SERVICE BULLETIN OSB 315-70

G103A TWIN II ACRO S/N 3544 – 34078 with suffix "K"

ATA-Code: 27-30 Flight Controls - Elevator
Elevator Rod II, Part-No. 103A-4241

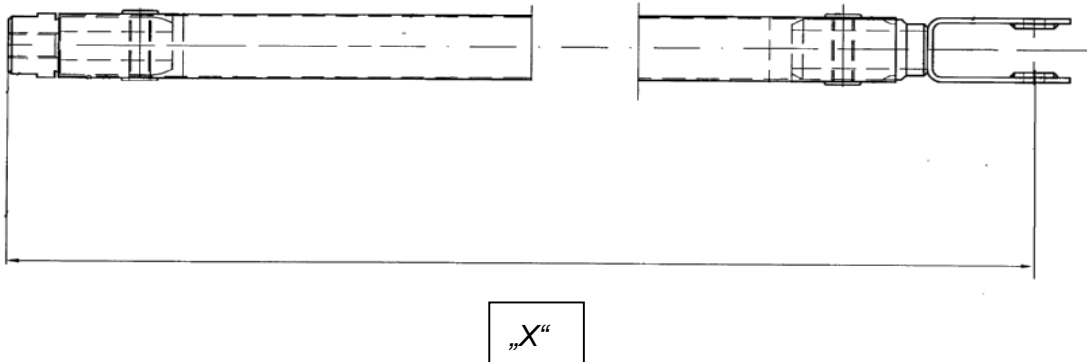
The TWIN II ACRO was built with elevator rod II, Part-Number 103A-4241. The tubing material for this elevator rod is no longer available in the required length. With this optional Service Bulletin the installation of the alternate elevator rod II, PN 103A-4241/2, made from different material, is permitted.

- 1.8.1. For spar parts order only elevator rod II, part number 103A-4241/2 with steel tubing dia.20 x 0,8 millimetres can be delivered. Because of that, the rod length and dimensions will not change.
- 1.8.2. A new weight and balance report must be generated and incorporated into the Flight Manual. For details see 1.10.

The new elevator rod 103A-4241/2 is 0,73kg (1,60 lbs) heavier. After installation the empty weight as well as the centre of gravity of the glider will change.

The new rod will be used for Serial-No. 3544 – 34078 with suffix “K” and can be ordered with part number 103A-4241/2 from GROB. Please advise required rod length “X” (see drawing) when ordering.
